TECHNICAL MEMORANDUM

To: American University Campus Plan Team

Date: May 19, 2011

Subject: Addendum to Transportation Report – American University 2011 Campus Plan

Figure 1: Summary of Recommendations

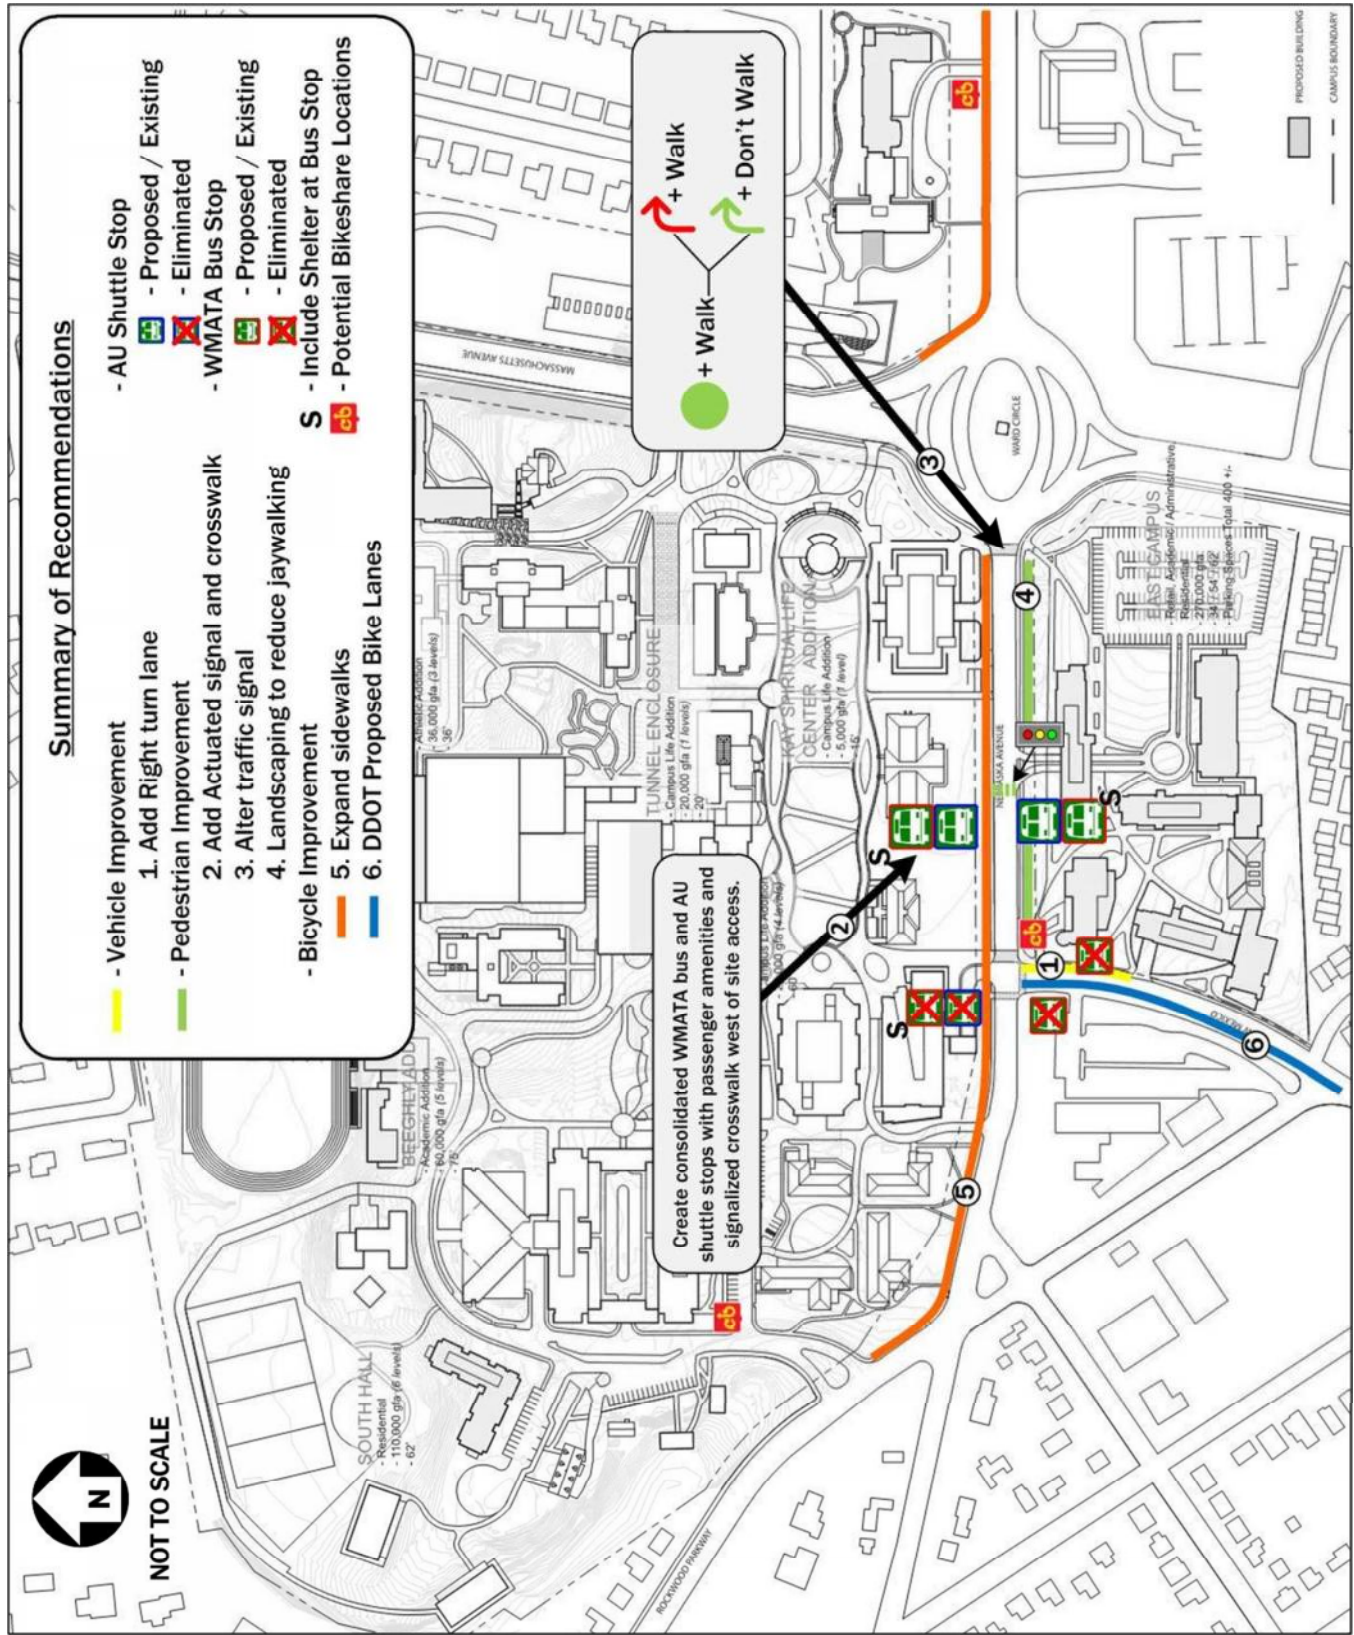
1. Removing the right-in/right-out driveway to the East Campus parking lot on Massachusetts Avenue leads to design changes on the East Campus that reduces the need for a pedestrian actuated traffic signal at the location of the right-in/right-out across from the NAC driveway. This Transportation Report now recommends that the concept of adding a pedestrian actuated traffic signal at this location be incorporated into the proposed study of Ward Circle as a short-term improvement.
2. The change to maintain the right-in/right-out driveway to the East Campus on Nebraska Avenue had the potential to lead to mid-block pedestrian crossings along Nebraska Avenue. To mitigate this concern, the Transportation Report is recommending construction of a pedestrian actuated traffic signal at the location of the right-in/right-out on Nebraska Ave.

The bus stop recommendations have been updated to reflect the access and crosswalk recommendations above. The Transportation Report now recommends that the six AU shuttle and Metrobus stops located along Nebraska Avenue and New Mexico Avenue adjacent to campus be consolidated into two stops, on opposite sides of the new pedestrian crossing on Nebraska Avenue. This will lead to a simpler routing for the campus population and fewer times when buses stop along Nebraska Avenue.

Figure 2: 40th Street and Fort Drive RCW2 Recommendations and Bus Stop Option A

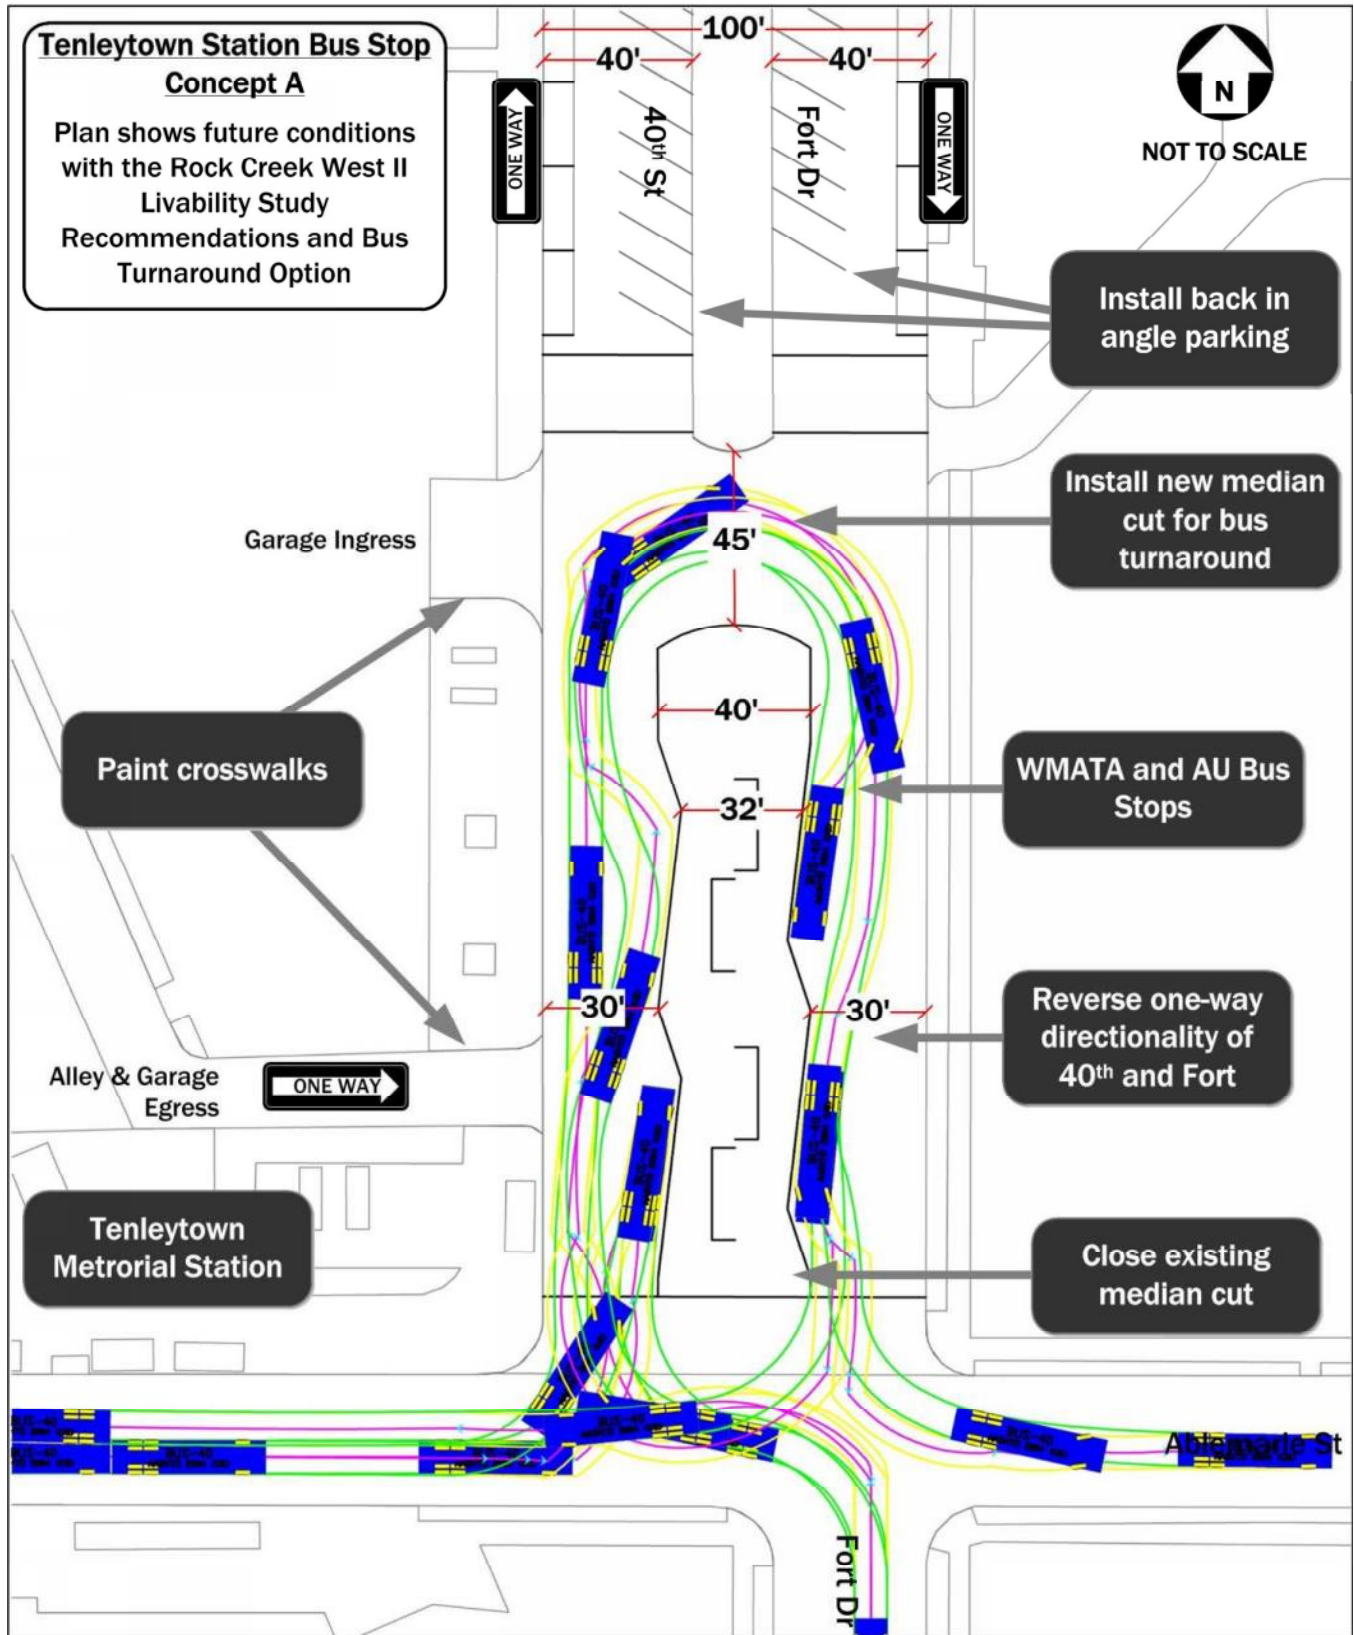
Figure 2 and Figure 3 illustrate two options for accommodating transit stops and incorporating RCW2 recommendations with some refinements. Both options incorporate all RCW2 recommendations north of the new median cut but make changes south of the median cut to better accommodate transit and pedestrian traffic.

Design Option A maximizes the amount of space provided for pedestrian and passenger activity. If maximizing the amount of on-street parking in the area is a priority, one lane of on-street parking could be accommodated on either 40th Street or Fort Drive if the pedestrian and passenger waiting area width is reduced. Option B illustrates on-street parking along the eastern curb of Fort Drive. Given the space constraints at this location, providing parking south of the median cut is possible, but it may not be desirable from a bus operations standpoint. Cars waiting for and maneuvering in or out of a parking space are likely to impede through traffic and bus maneuvers.

Figure 3: 40th Street and Fort Drive RCW2 Recommendations and Bus Stop Option B

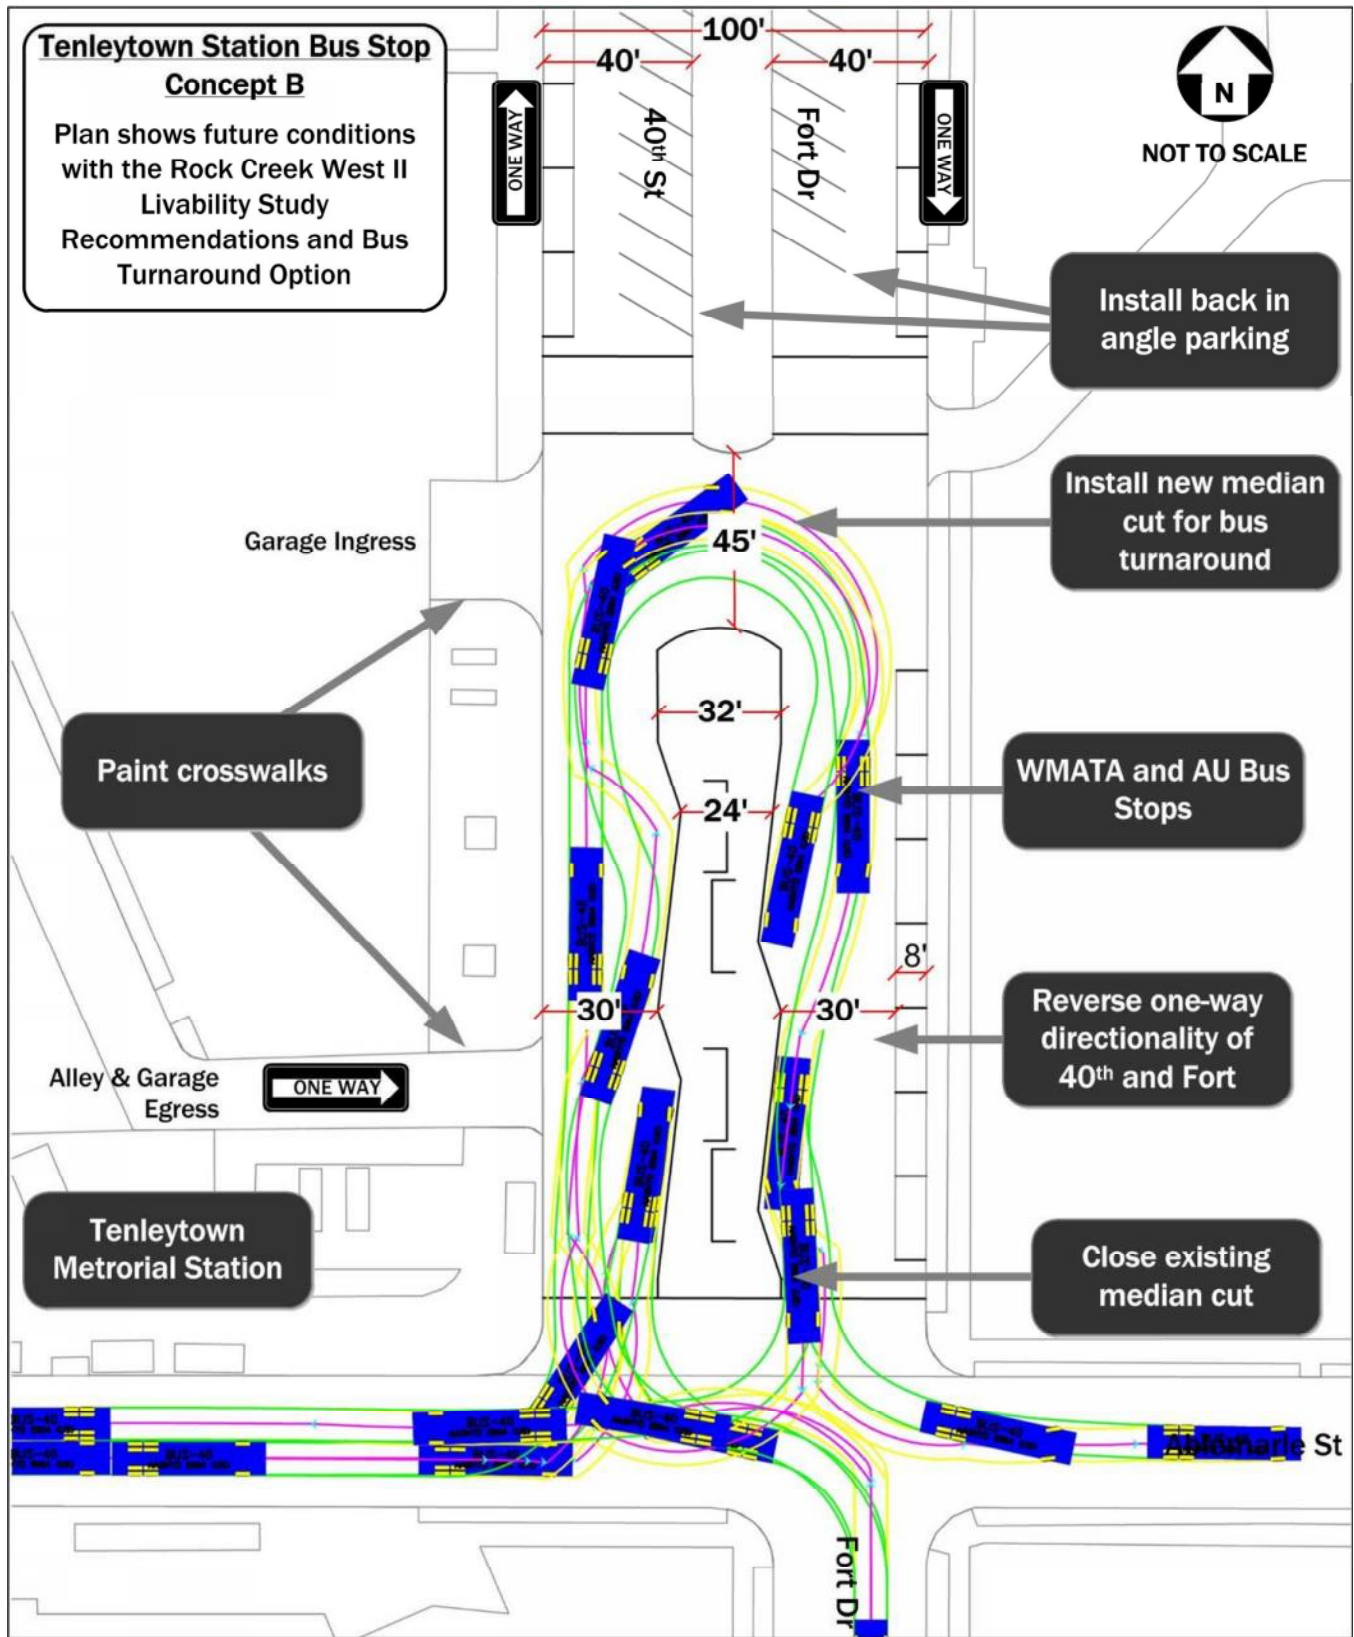
The primary difference between the RCW2 design and Option A and Option B is the design of the bus stops and the amount of parking provided. There are several options for accommodating bus stops and pedestrians, the two presented below maximize the amount of space for pedestrians and passengers and adhere to the standards and guidelines contained in the 2008 “WMATA Bus Station Design Guidelines”. The guidelines state that sawtooth bays are the standard design for WMATA bus facilities because they require significantly less curb space than tangent bays. The figure in the RCW2 study illustrating the recommendations included tangent bays, but the ones shown do not adhere to the WMATA standards. Following the WMATA standards, it is difficult to accommodate the four bus stops south of the proposed median cut because tangent bays require much more curb length per stop (114’) than a sawtooth (70’). As result, Gorove/Slade recommends using sawtooth bays.

Figure 14: Total Future Traffic Controls, Lane Designations, and AM Traffic Volumes with Proposed Signal

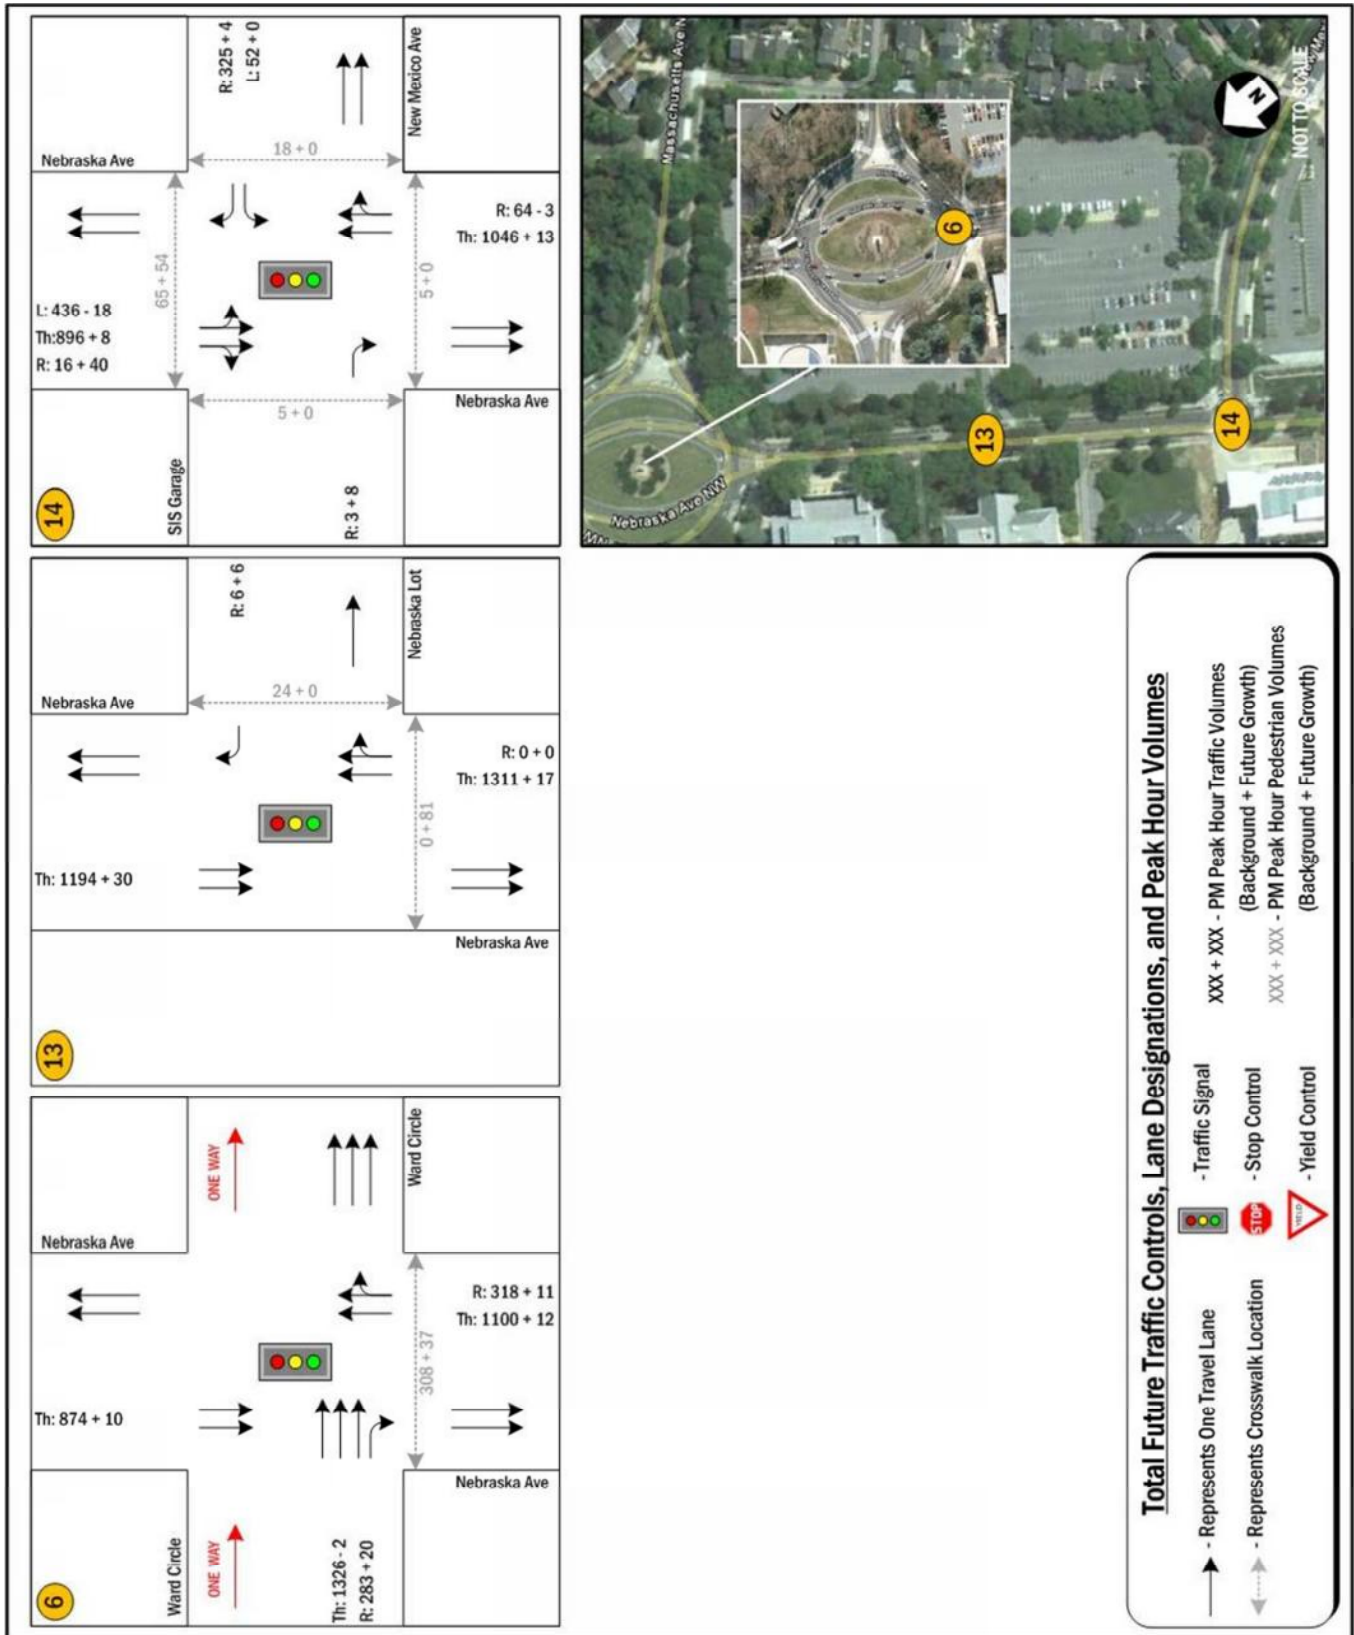
In addition to the analysis presented above, a second analysis was performed in order to determine the impact of a proposed traffic signal located at the existing right-in/right-out (RIRO) driveway along Nebraska Avenue. A signal is proposed at this location in order to provide an additional location for pedestrians to cross Nebraska Avenue due to the

development on the East Campus. This traffic signal would allow for vehicles to exit the East Campus, as well as allow pedestrians to cross at a signalized location, moving pedestrians away from the adjacent signalized crossings. Trip distribution for the pedestrian trips added by the East Campus was based on an approximate 50%/35%/15% split of pedestrians between the New Mexico Avenue, RIRO driveway, and Ward Circle crossings along Nebraska Avenue, respectively, due to the layout of the site. The future pedestrian volumes added to the crosswalks affected by the 2011 Plan are shown in Table 4. The future pedestrian volumes for the affected crosswalks are shown on Figure 14 and Figure 15 for the morning and afternoon peak hours, respectively.
